**NOTICE OF ADDENDUM
ADDENDUM 2
CONTRACT NO. 8712
LOWELL STREET ASSESSMENT DISTRICT – 2024**

UTILITY PLAN & PROFILE PROPOSED
LOWELL ST RECONSTRUCTION
M:\DESIGN\Projects\14078\CAD\Servers\14078SWR-PipeNetwork.dwg

14078
U-1

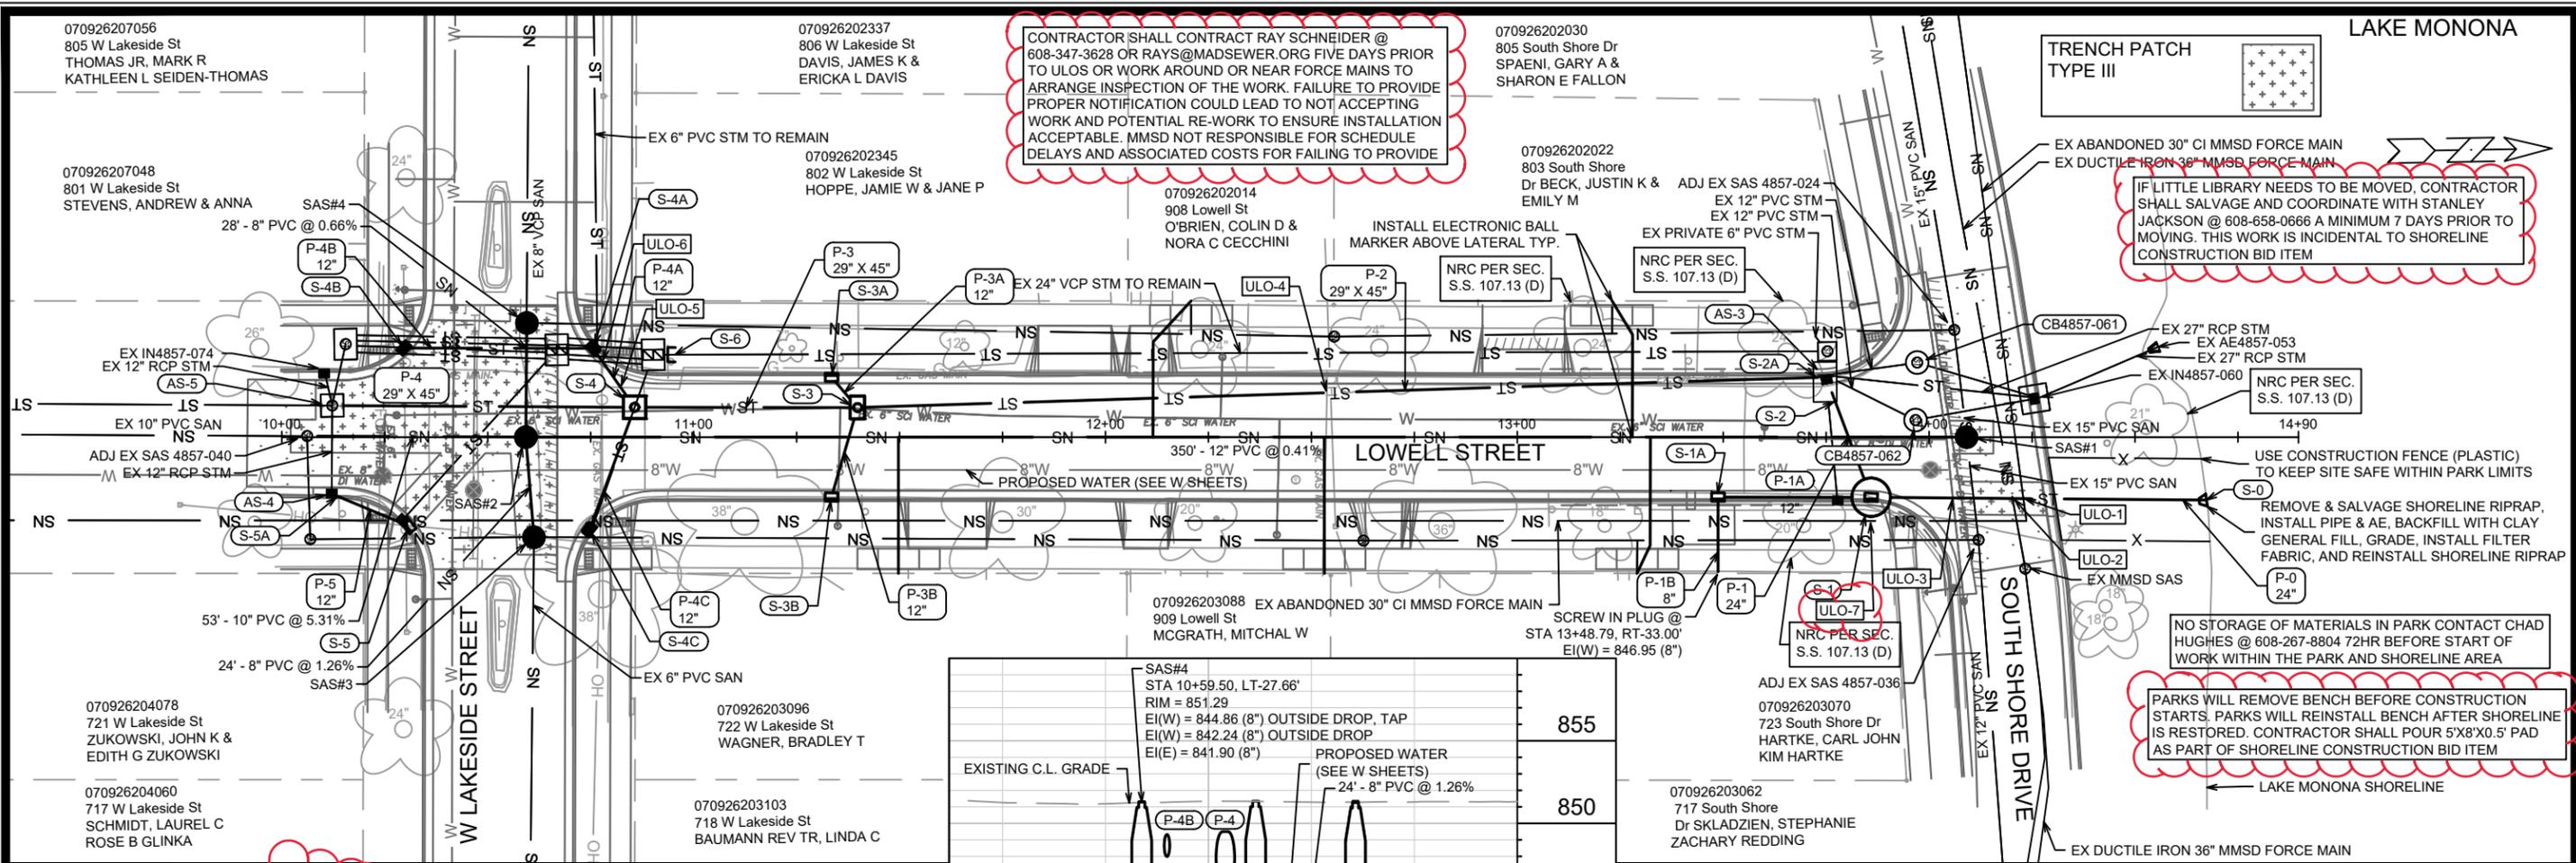
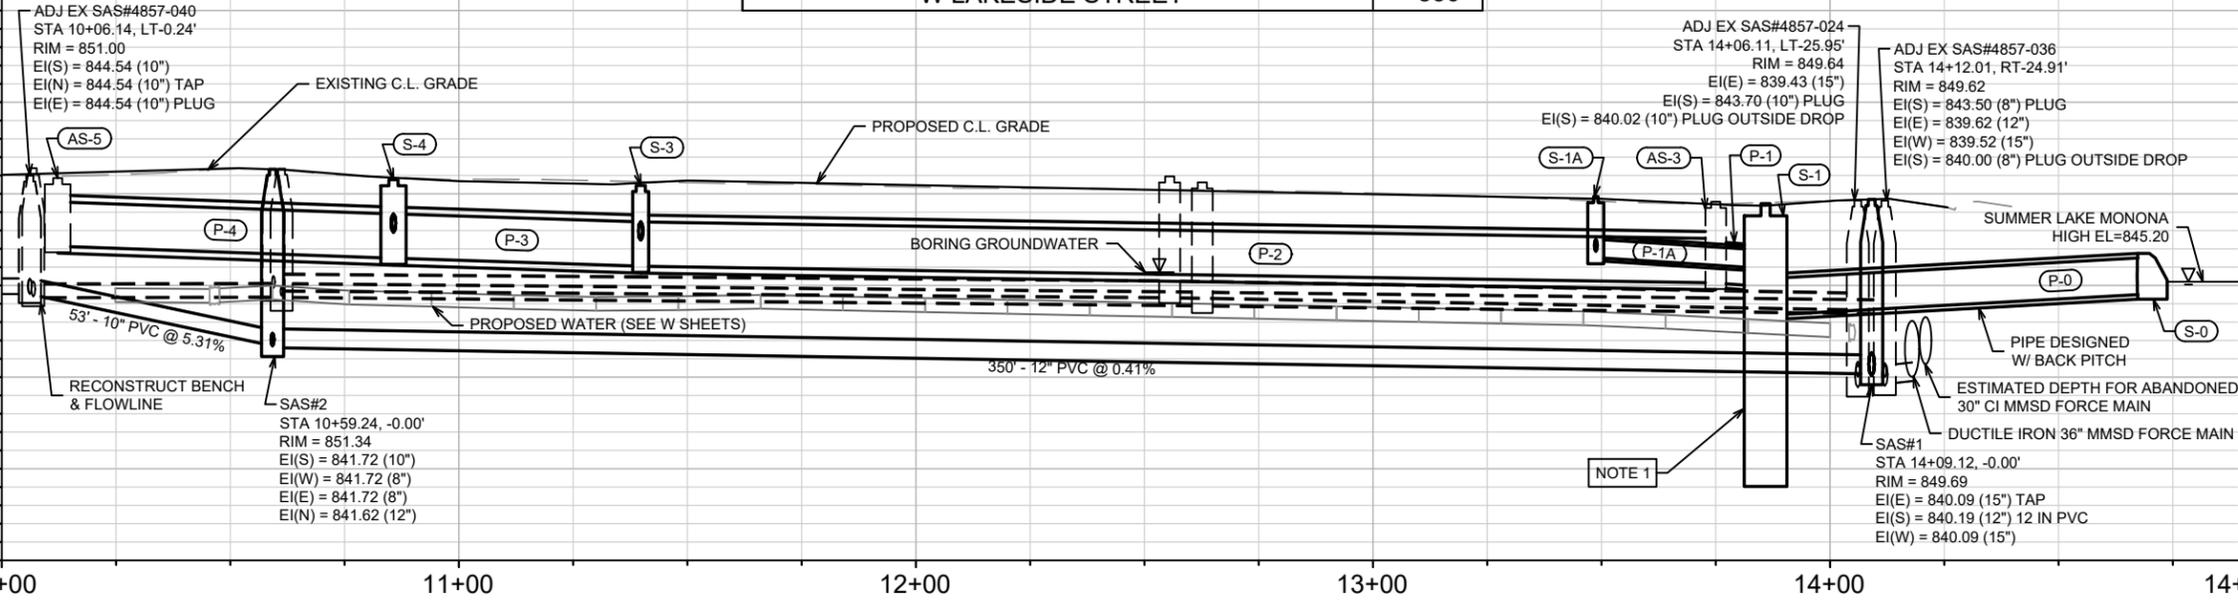
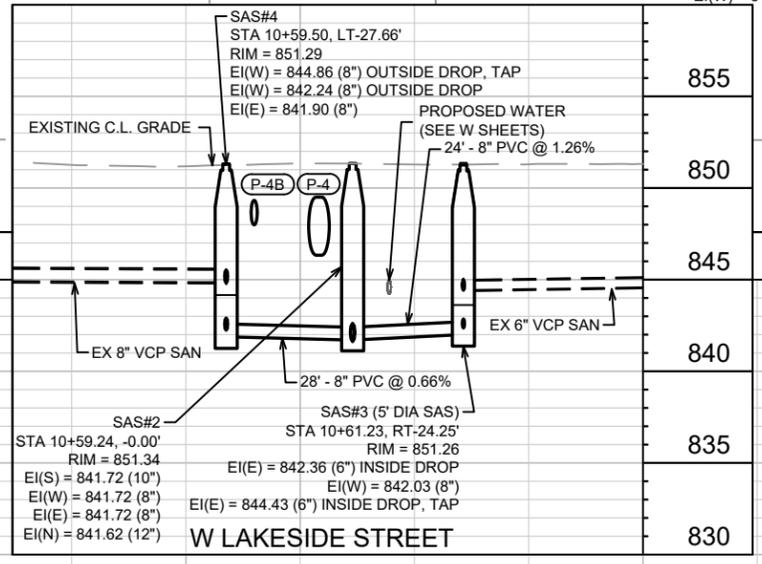
U-1: Added additional coordination and requirements for work around MMSD Forced mains, Parks area, and Little Library. Added ULO-7 on the abandoned MMSD forced main.

CONTRACTOR SHALL CONTRACT RAY SCHNEIDER @ 608-347-3628 OR RAYS@MADSEWER.ORG FIVE DAYS PRIOR TO ULOS OR WORK AROUND OR NEAR FORCE MAINS TO ARRANGE INSPECTION OF THE WORK. FAILURE TO PROVIDE PROPER NOTIFICATION COULD LEAD TO NOT ACCEPTING WORK AND POTENTIAL RE-WORK TO ENSURE INSTALLATION ACCEPTABLE. MMSD NOT RESPONSIBLE FOR SCHEDULE DELAYS AND ASSOCIATED COSTS FOR FAILING TO PROVIDE

IF LITTLE LIBRARY NEEDS TO BE MOVED, CONTRACTOR SHALL SALVAGE AND COORDINATE WITH STANLEY JACKSON @ 608-658-0666 A MINIMUM 7 DAYS PRIOR TO MOVING. THIS WORK IS INCIDENTAL TO SHORELINE CONSTRUCTION BID ITEM

NO STORAGE OF MATERIALS IN PARK CONTACT CHAD HUGHES @ 608-267-8804 72HR BEFORE START OF WORK WITHIN THE PARK AND SHORELINE AREA

PARKS WILL REMOVE BENCH BEFORE CONSTRUCTION STARTS. PARKS WILL REINSTALL BENCH AFTER SHORELINE IS RESTORED. CONTRACTOR SHALL POUR 5'X8'X0.5' PAD AS PART OF SHORELINE CONSTRUCTION BID ITEM
